**SUPPLEMENTARY REPORT OF DAMON KENNY, EXECUTIVE PLANNER
DATED 29 AUGUST 2023**

SUBJECT: **LPP01: 451-455 Miller Street, Cammeray**

APPLICATION NO. **DA 248/22**

1. Purpose of the Addendum

Figure 1: Roof plan detailing the location of the ventilation exhaust

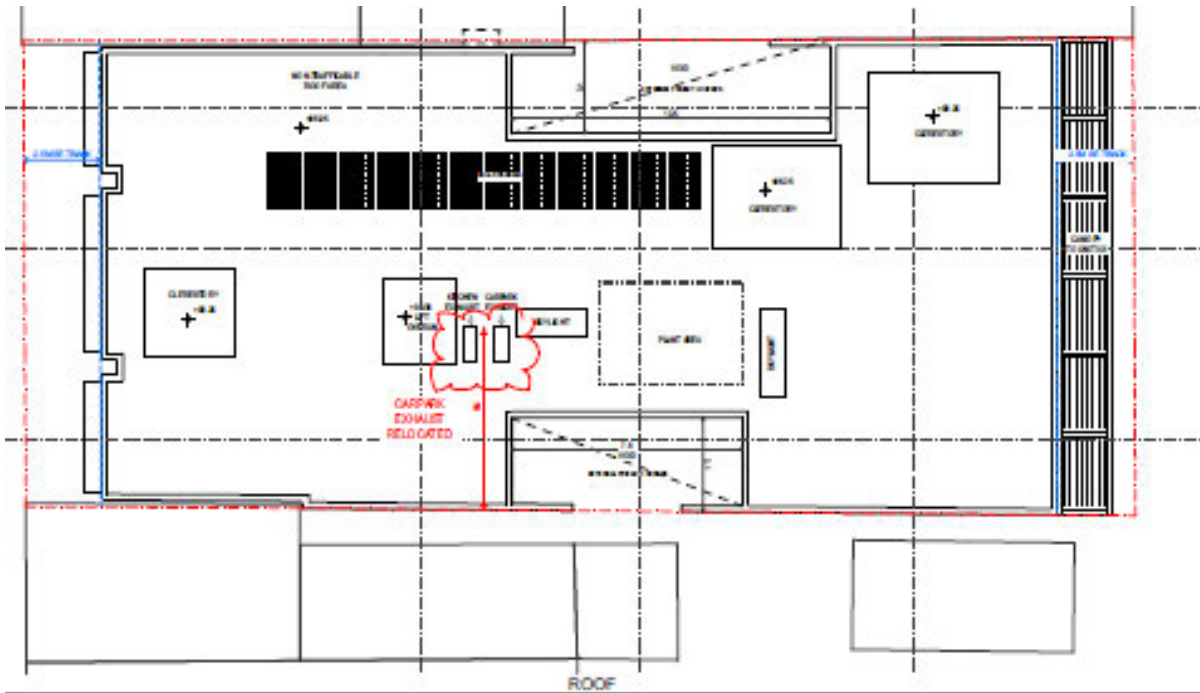
Mechanical ventilation servicing the carpark

The applicant submitted revised plans detailing the proposed mechanical ventilation of the basement car park. The car park ventilation duct has been located on the rooftop of the proposed building with a setback of 6m from the property boundary. Further, the amended architectural plans show the ventilation duct below the maximum building height proposed, therefore an amended Clause 4.6 is not required.

E-04 SOUTH ELEVATION
1:100

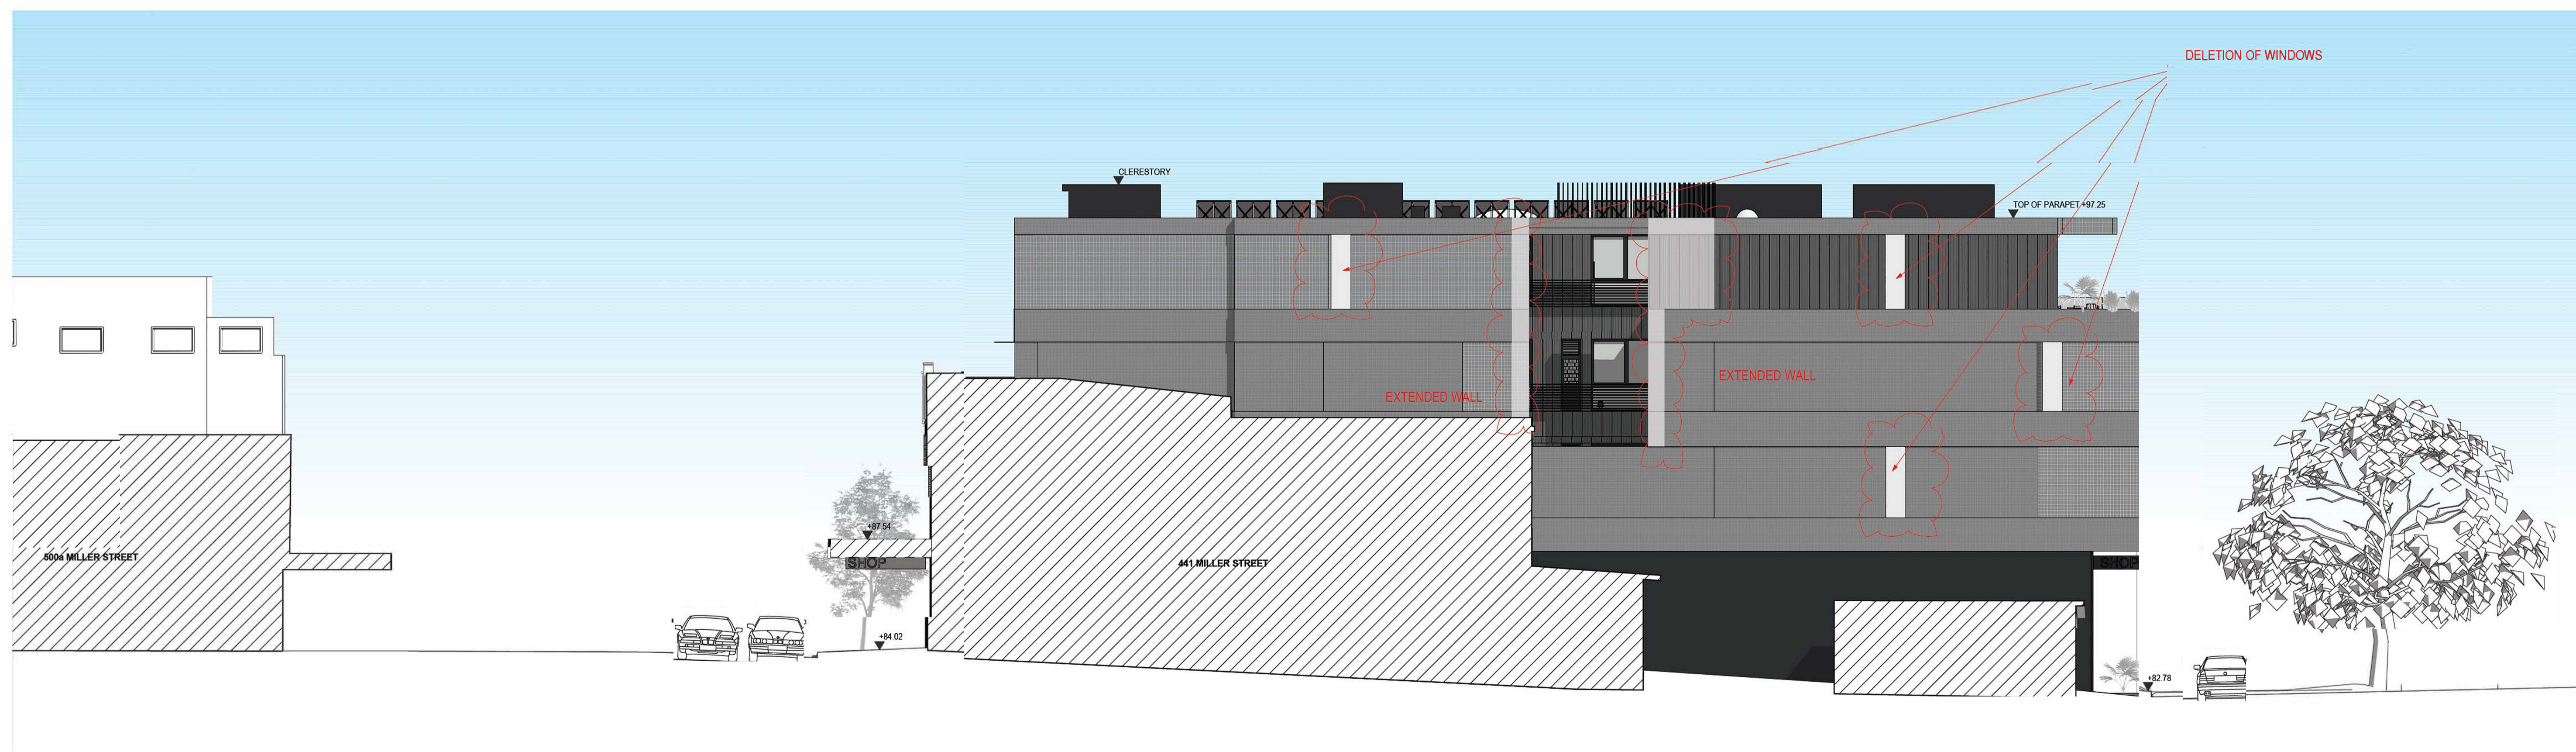
Concerns were raised regarding the future development of the adjoining sites and the impacts on the proposed development with regard to the windows located on the northern and southern side property boundaries and in addition privacy. The applicant has provided amended plans deleting windows on the southern elevation and proposes a condition of consent imposing a covenant on the title of each of the units with windows abutting the northern boundary advising that should the adjoining site be developed the subject windows will be required to be removed or fire rated in accordance with the BCA.

To address the comments made by Panel members, the DA drawings have been amended to delete all windows on the south façade of the building.
